Remarks/Arguments:

Applic. No. 10/699,134
Amdt. dated March 16, 2005
Reply to Office action of December 16, 2004

Fig. 1a
PRIOR ART

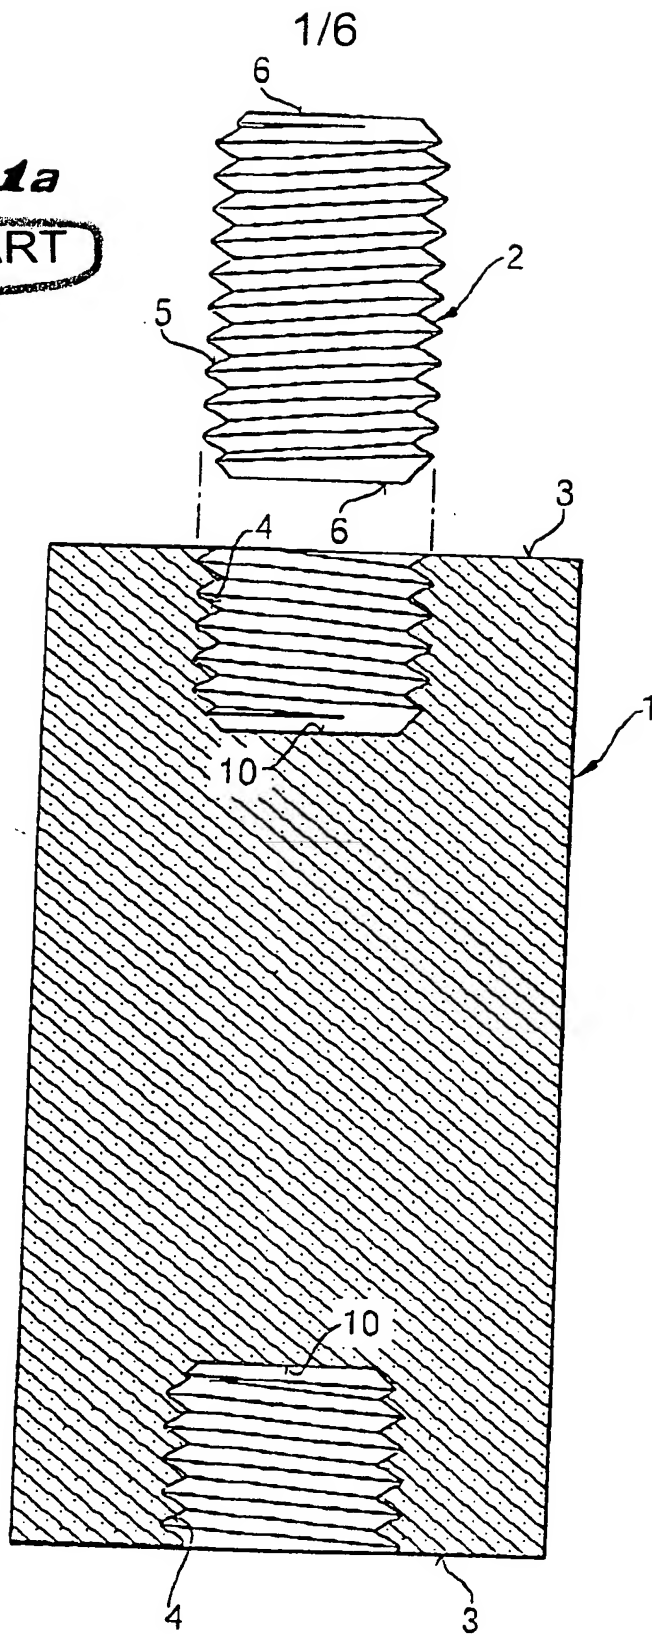
In the first paragraph on page 2 of the above-identified Office action, the Examiner stated that Figs. 1a, 1b, and 3a should be designated by a legend such as --Prior Art--. As noted above in the "Drawing Amendments" section, Figs. 1a, 1b, and 3a have been labeled "Prior Art".

The attached sheets of drawings includes changes to Figs. 1a, 1b, and 3a. These sheets which includes Figs. 1a, 1b, and 3a, replace the original sheets including Figs. 1a, 1b, and 3a. Figs. 1a, 1b, and 3a, are now designated as "Prior Art"

Please approve the drawing changes that are marked in red on the accompanying "Annotated Sheets Showing Changes" of Figs. 1a, 1b, and 3a. Formal "Replacement Sheets" of amended Figs. 1a, 1b, and 3a are also enclosed.
